BAUTISTA MIXED-USE PROJECT

INFILL INCENTIVE DISTRICT DESIGN SUBMITTAL

First Round comment responses: Case # IID-21-02
Related Activity Number: #DP21-0157, T21PRE0091

03.02.2022

Scale	Sheet
Job No. 113010-Q-001-0105/0600	3
Date DECEMBER 2021	
Designed By JF	
Checked By DWL

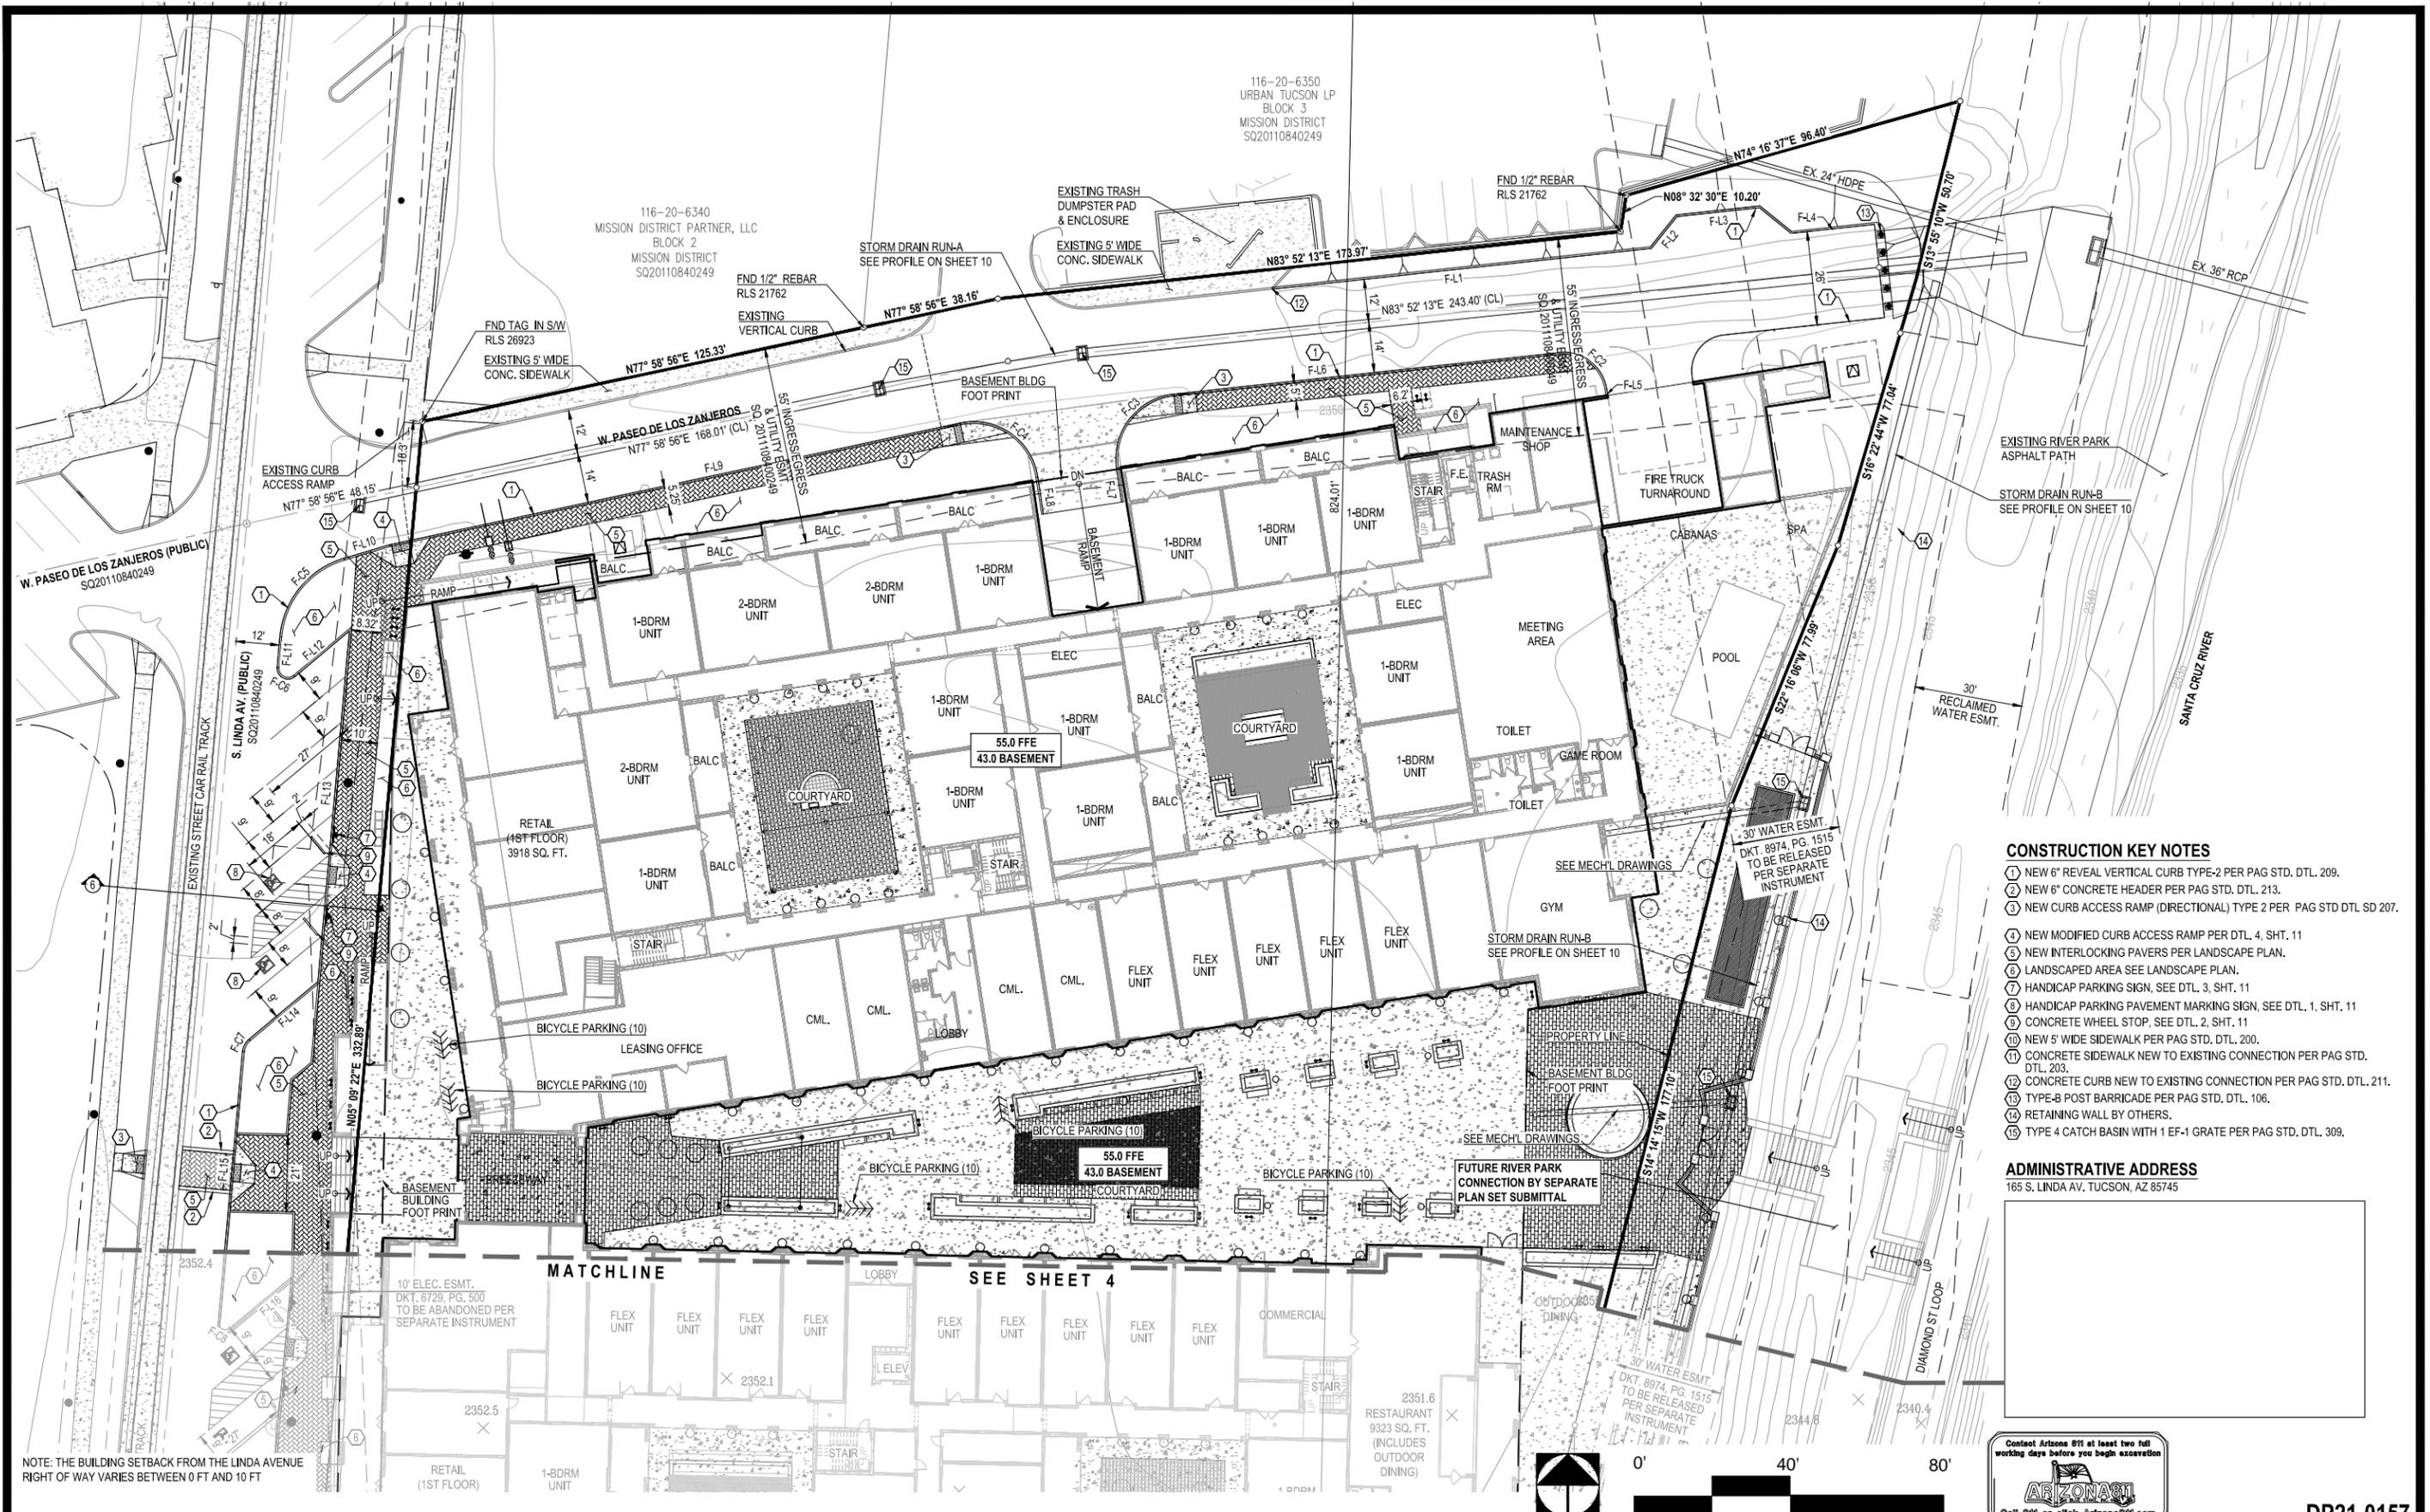
5. Please revise the construction key note for the handicap parking pavement marking sign and for the concrete wheel stop to match with what is on the list to the right. (Sheet 3) **WLB Response: Keynote has been corrected.**

TOTAL REQUIRED PARKING: 377 SPACES
 TOTAL PROVIDED ONSITE: 256 SPACES
 ADDITIONAL PARKING WILL BE PROVIDED FOR OFFSITE. AN INDIVIDUAL PARKING PLAN (IPP) WILL BE PREPARED AND SUBMITTED ALONG WITH THE INFILL INCENTIVE DISTRICT (IID) APPLICATION.

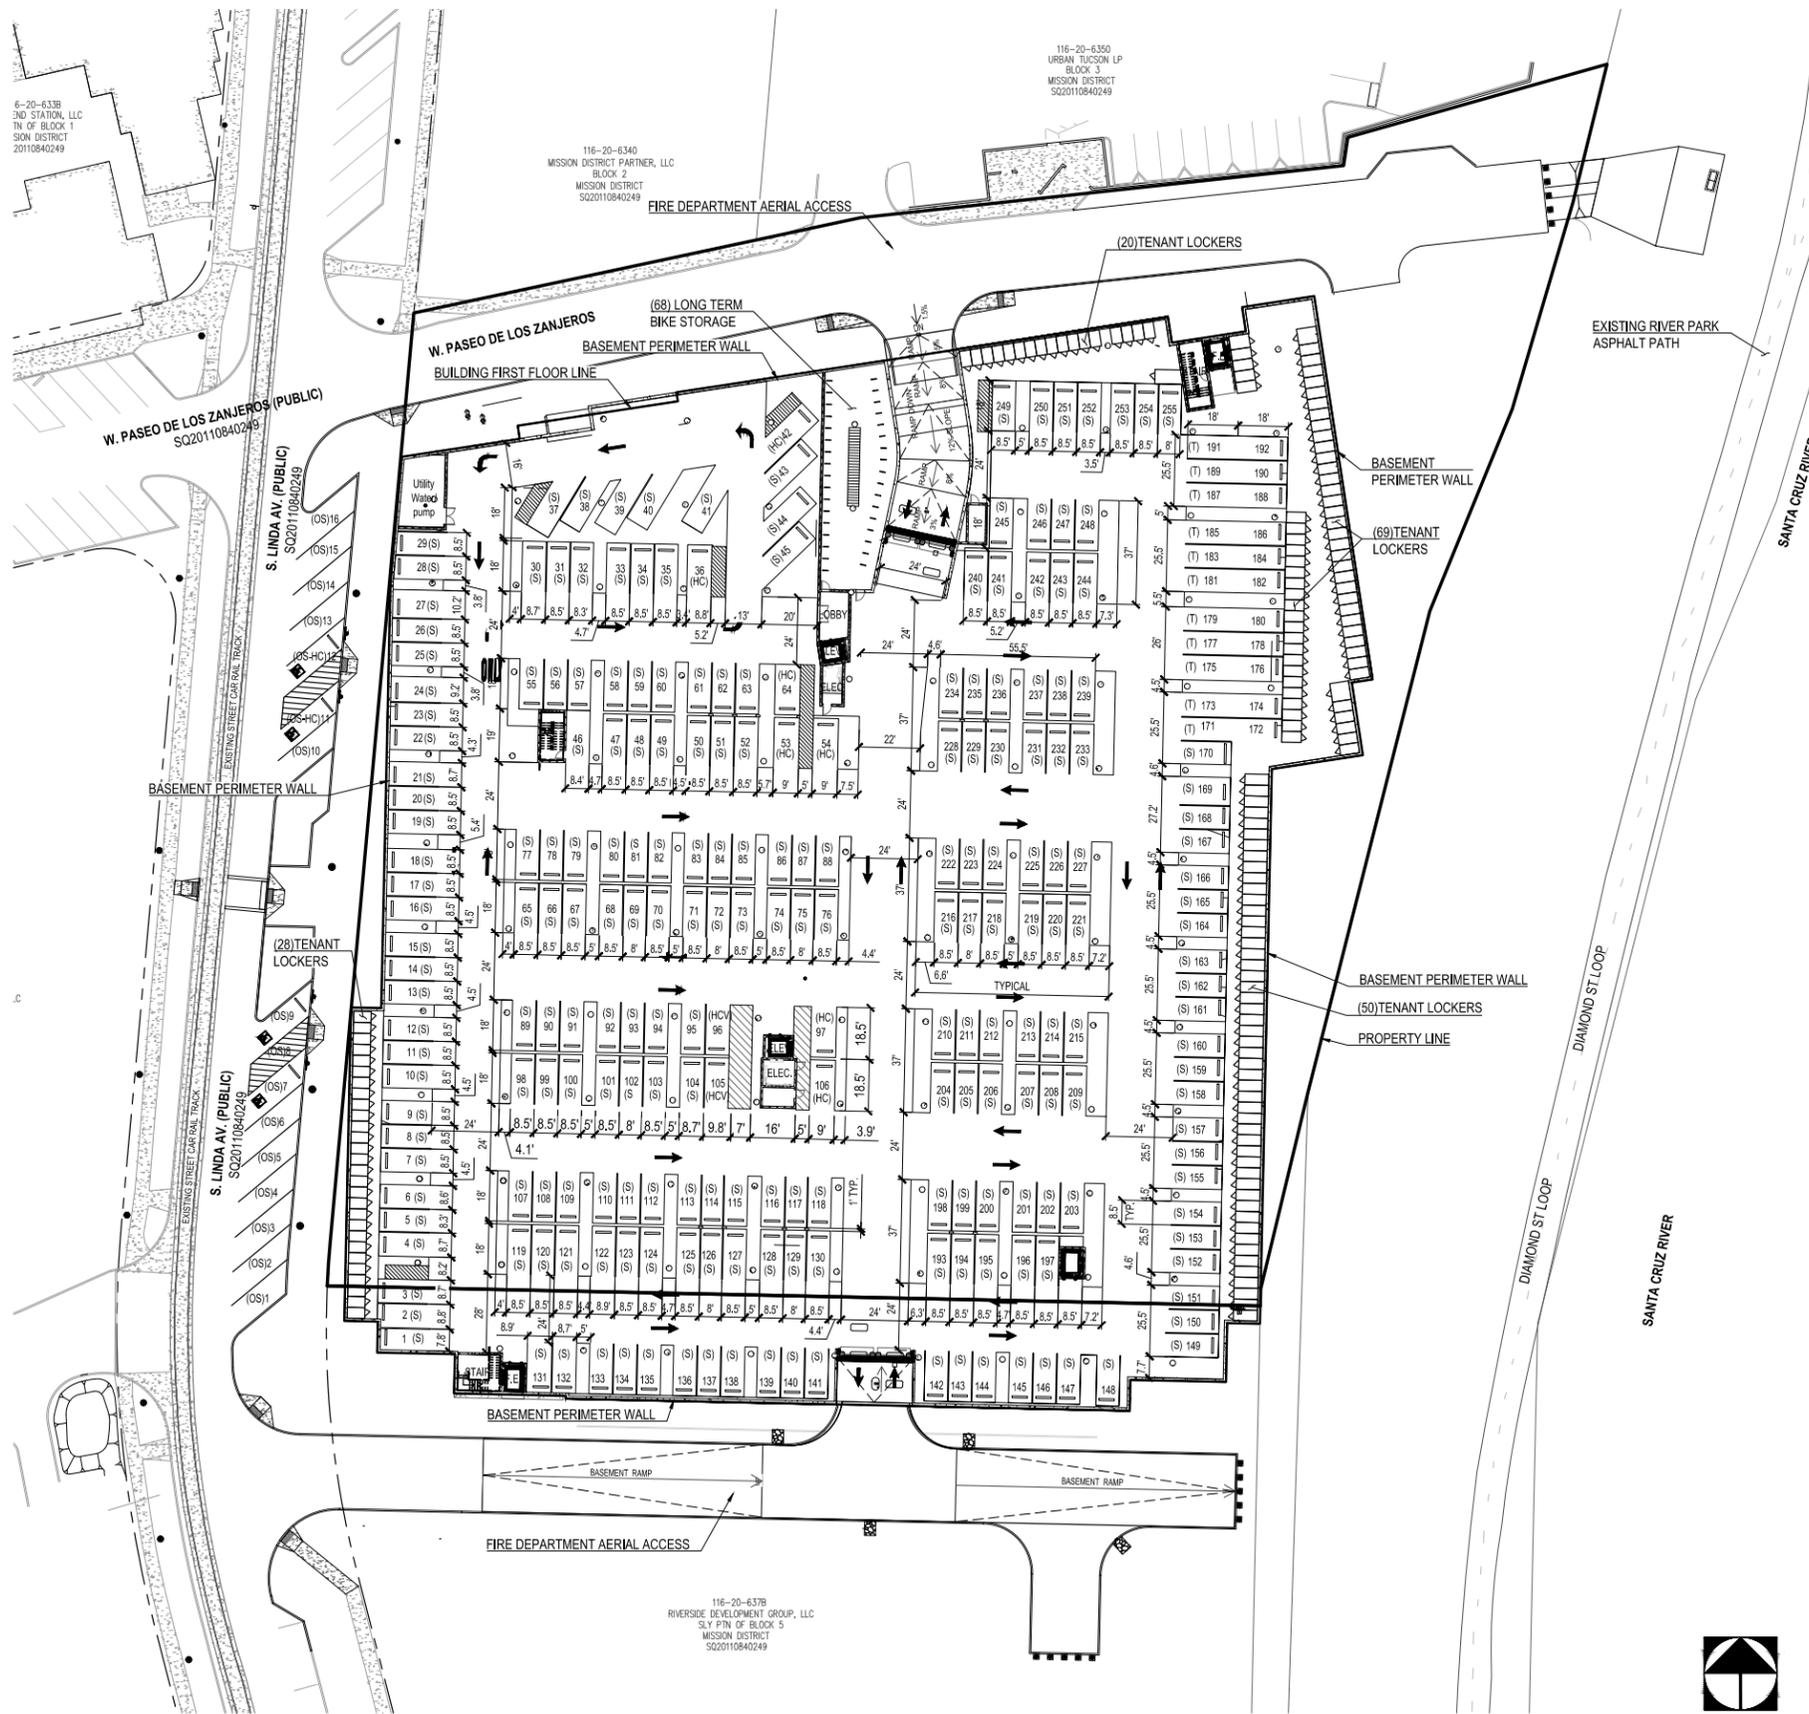
26. 2-06.4.9.H.5.d – Provide the number of short term bicycle parking spaces provided. **WLB Response: The number provided is 46 spaces, which is noted on Sheet 5 and shown on Sheets 3 and 4.**

2. Include waste calculations to represent service level (size and frequency) and type of service (Front load, roll-off, compactor, etc.) provide detail/specifications of the enclosure and maneuverability. Refer to TSM 8-01.4, 8-01.5, 8-01.8.0. **WLB Response: Please see Sheet 5 for the calculation matrix.**

Sheet **9**

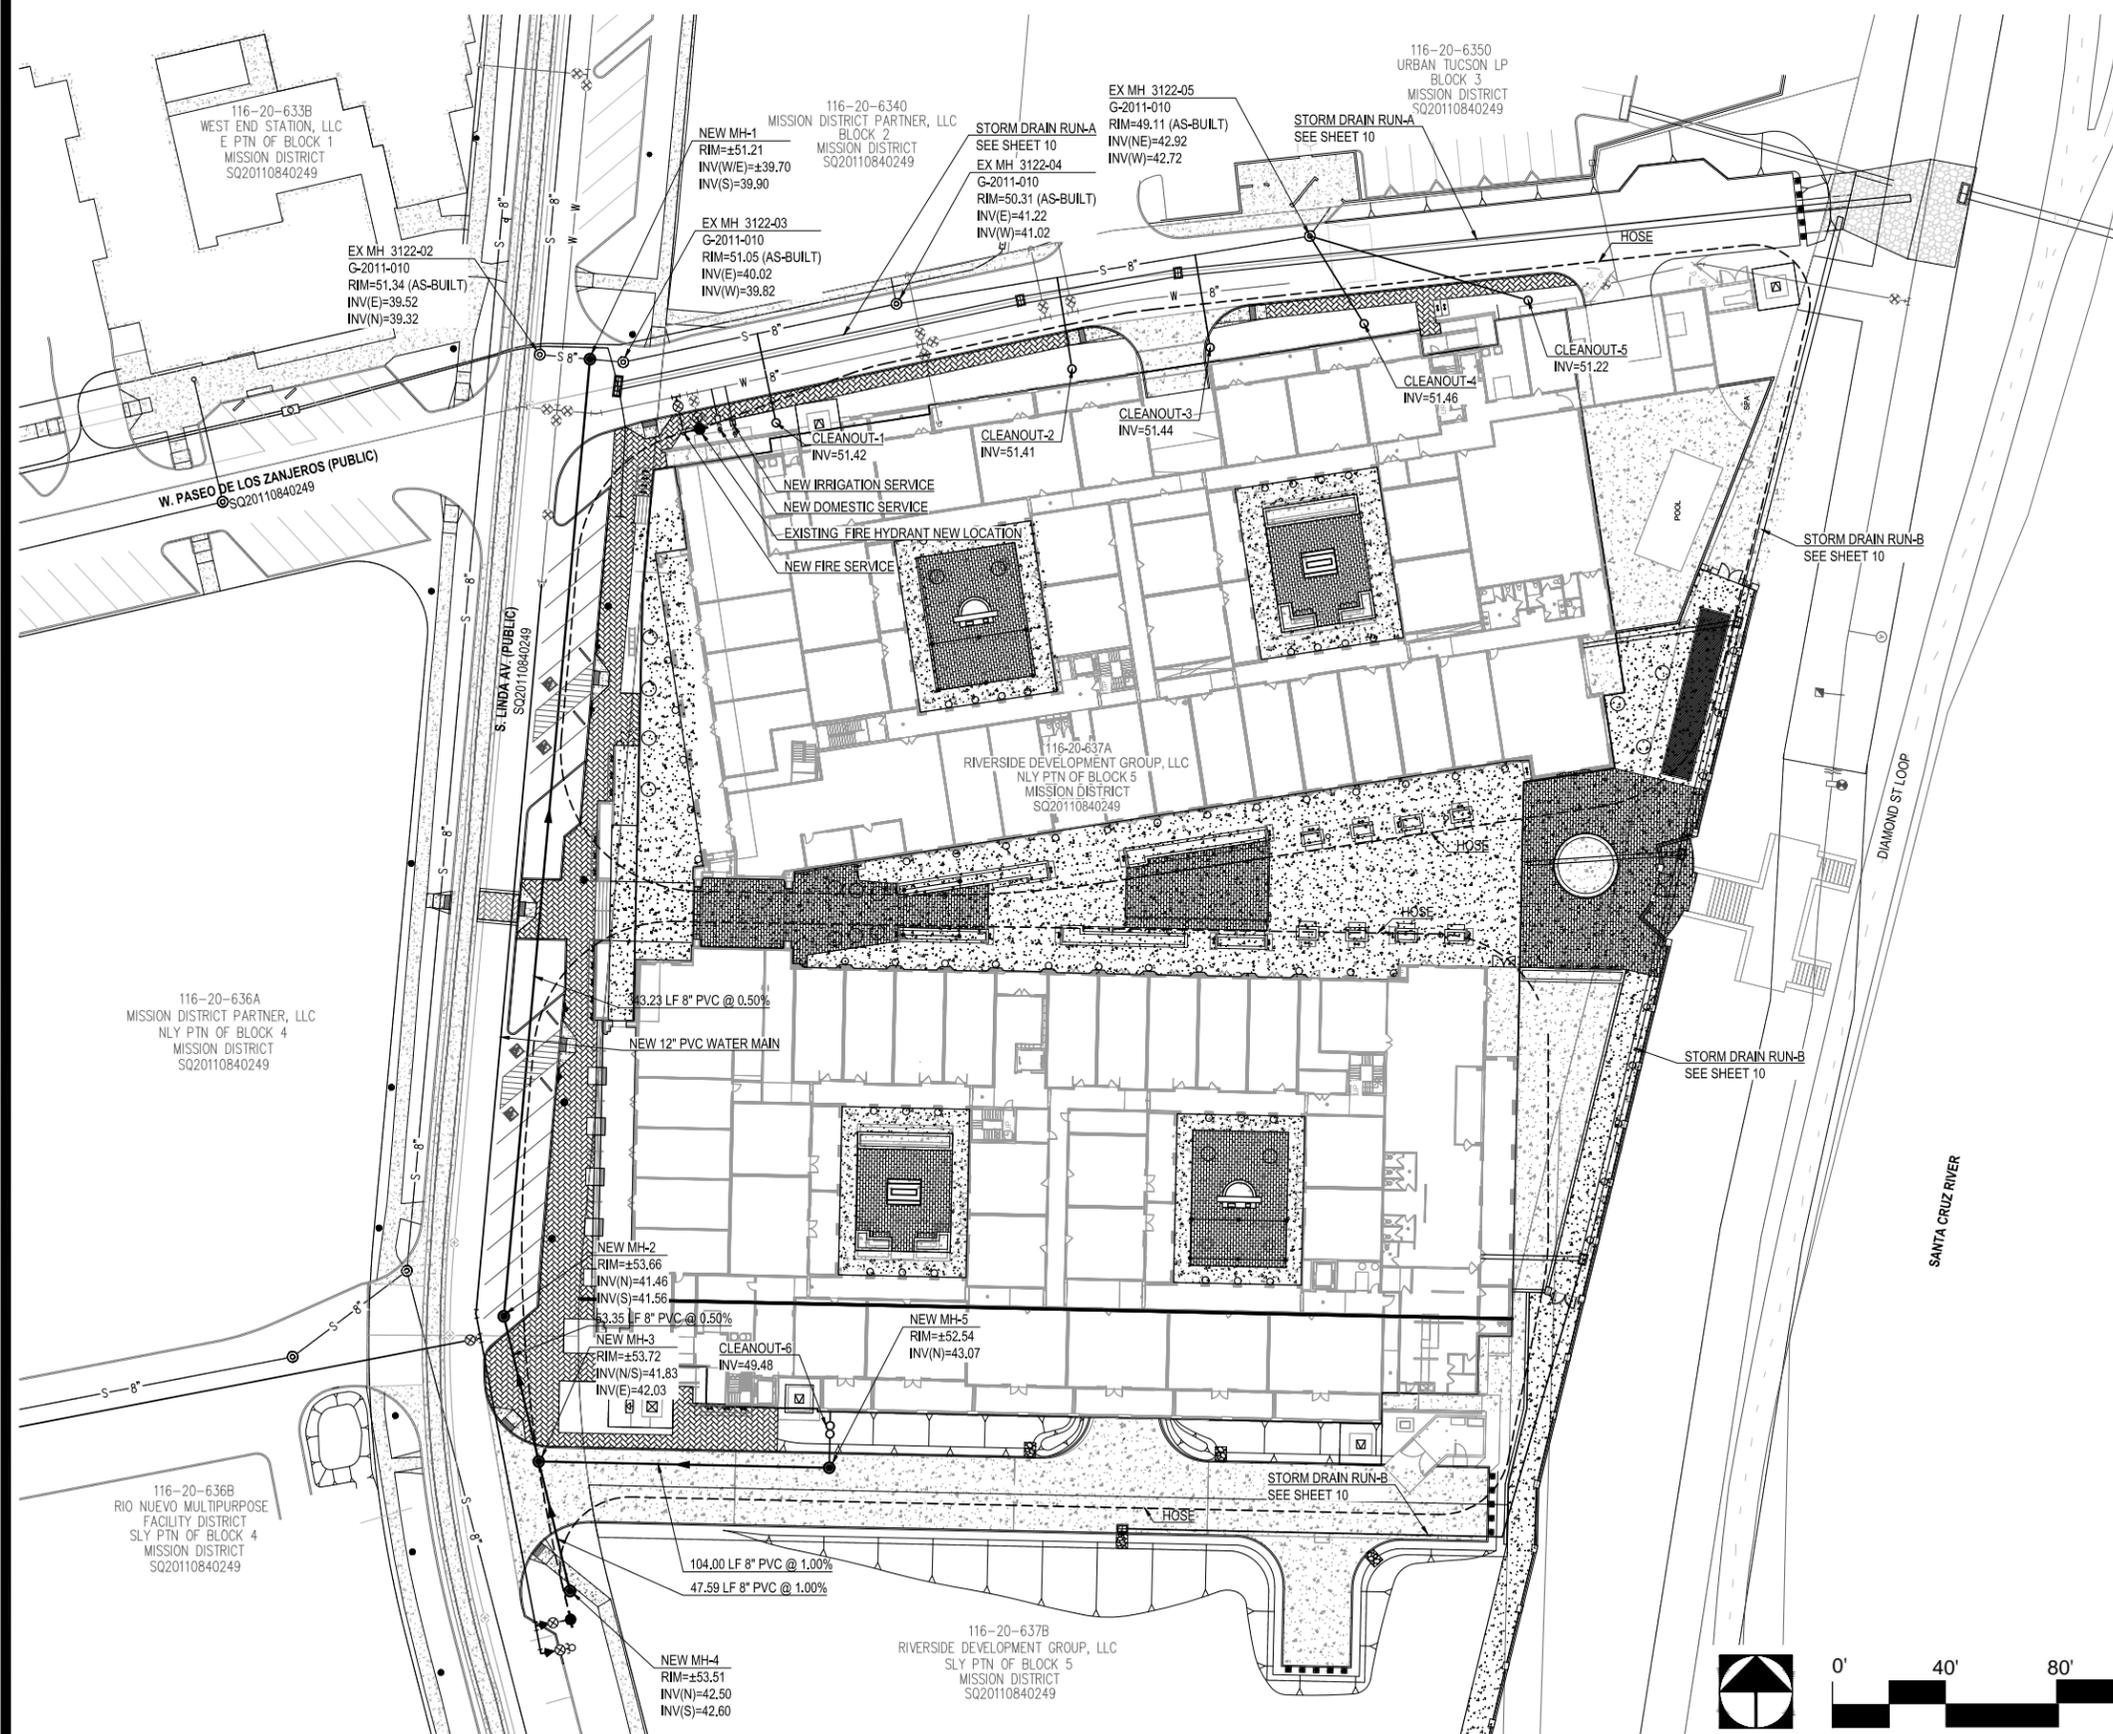
19. Provide slope and elevations for all proposed curb access ramps. (Sheet 8) **WLB Response: This information has been added.**
20. Provide all invert elevations for all laterals, Include the slope and length of pipe. (Sheet 9) **WLB Response: This information has been added.**

21. Please include the INV(W) elevation. (Sheet 9) **WLB Response: The west invert elevation has been added.**
22. Please provide the stationing to verify the storm drain that is being shown on the profiles. (Sheet 9) **WLB Response: The stationing is now shown.**

5 LINDA AVE. W/ ANGLED PARKING
TYPICAL CROSS SECTION
N.T.S.

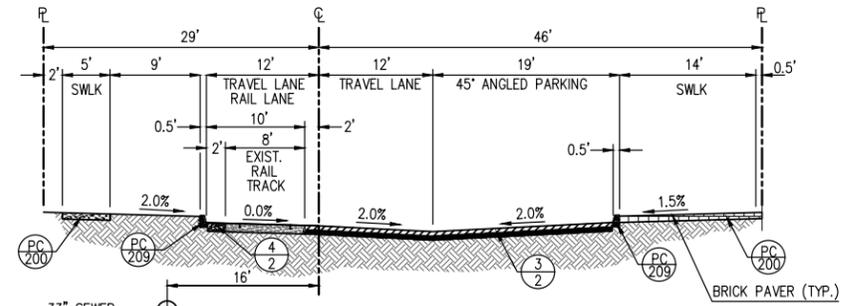
12. Please add slope and provide a cross section of S. Linda Ave that includes the parking stalls and add to the details sheet. (Sheet 7) **WLB Response: The slope has been added and a Linda Avenue cross section was added to Sheet 11.**
